HISTORIC AND DESIGN REVIEW COMMISSION

August 16, 2017

HDRC CASE NO: 2017-406
ADDRESS: 303 KING WILLIAM
LEGAL DESCRIPTION: NCB 742 BLK 1 LOT 4, NE 75.4 FT OF 3 & E 25.1 FT OF 5
ZONING: RM-4, HE
CITY COUNCIL DIST.: 1
DISTRICT: King William Historic District
LANDMARK: Stevens / James House
OWNER: Martin Phipps
TYPE OF WORK: Installation of fencing and a planter box in the front yard planting strip and at sidewalk

DESCRIPTION: SITE PLAN

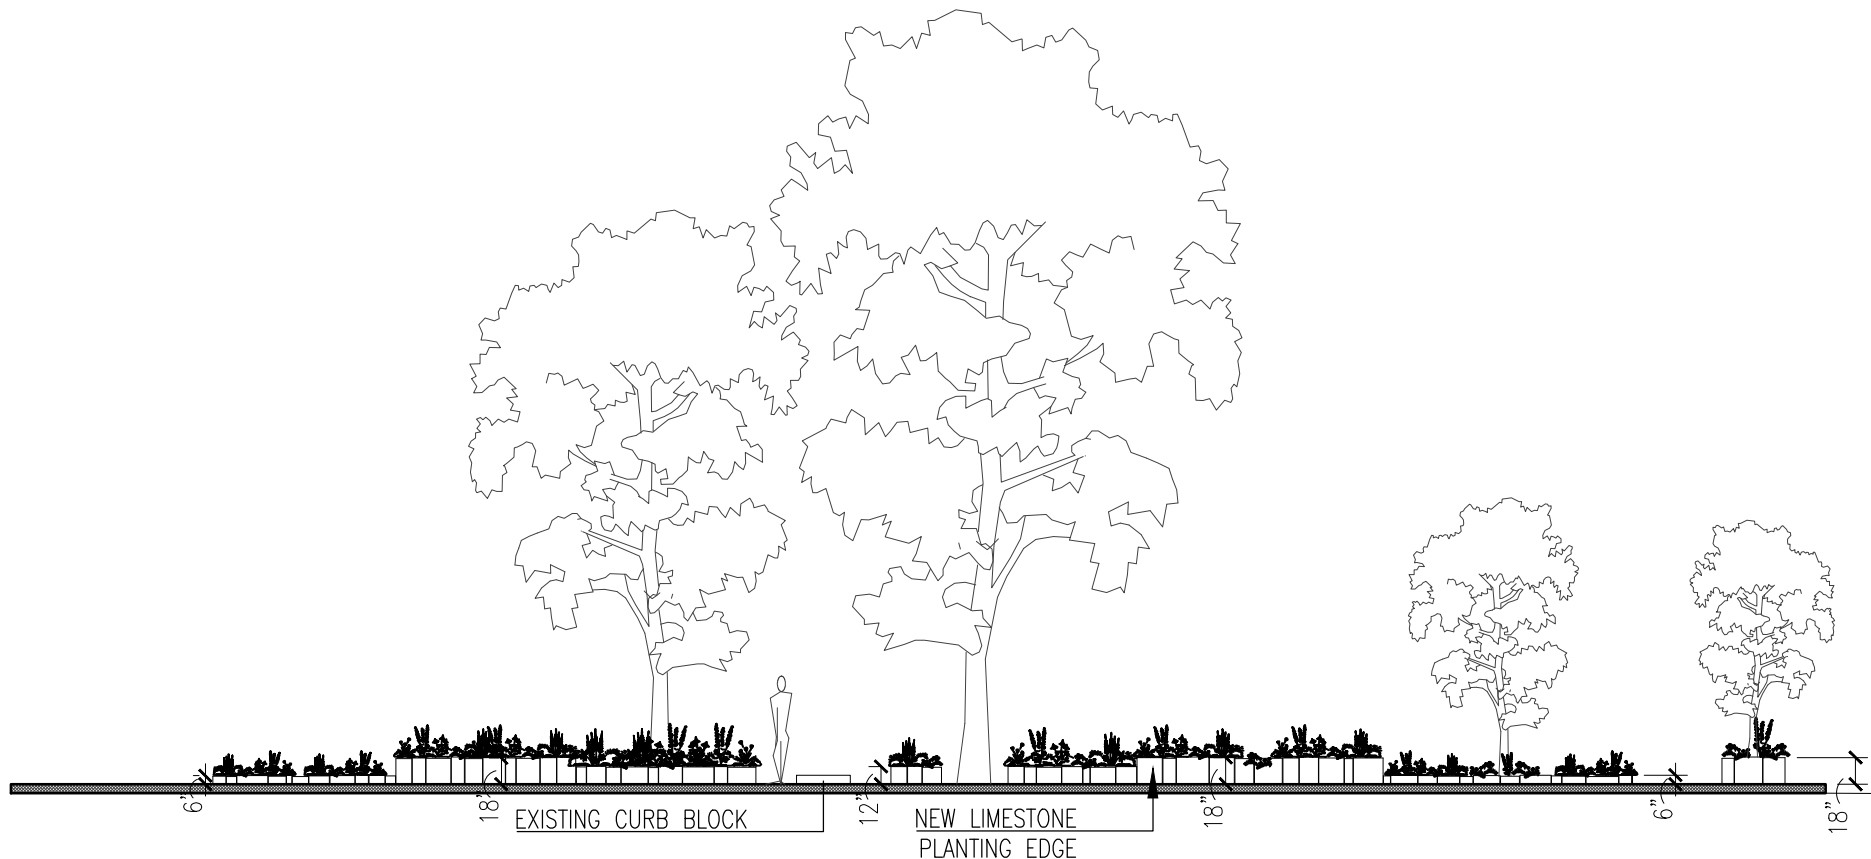
- b. FENCING – At the base of the existing front yard fencing and outside of the property line, the applicant has proposed to install an eighteen (18) inch tall wrought iron fence. The proposed fencing would be located in the public right of way; however, there are historic examples of fencing located adjacent to the sidewalk at the public right of way on King William Street and throughout the King William Historic District. Staff finds this installation to be appropriate based on existing, historic examples.

- c. PLANTING BOX – In the public planting strip between the sidewalk and streets, the applicant has proposed to construct a limestone planter to feature saw chopped limestone and heights to range from six to eighteen inches in height. As the proposed wrought iron fencing, the proposed limestone planter is proposed to be located within the public right of way. Landscaping materials vary in the planting strips along King William Street; however, there

are no historic examples of raised or walled planting beds in the planting strips. Staff does not find this installation appropriate.

Staff does not recommend approval of item #1, the installation of a limestone planting box within the front planting strip based on finding c.

Staff recommends approval of item #2, the installation of wrought iron fencing based on finding b. The applicant is responsible for meeting any right of way permitting requirements that may apply.
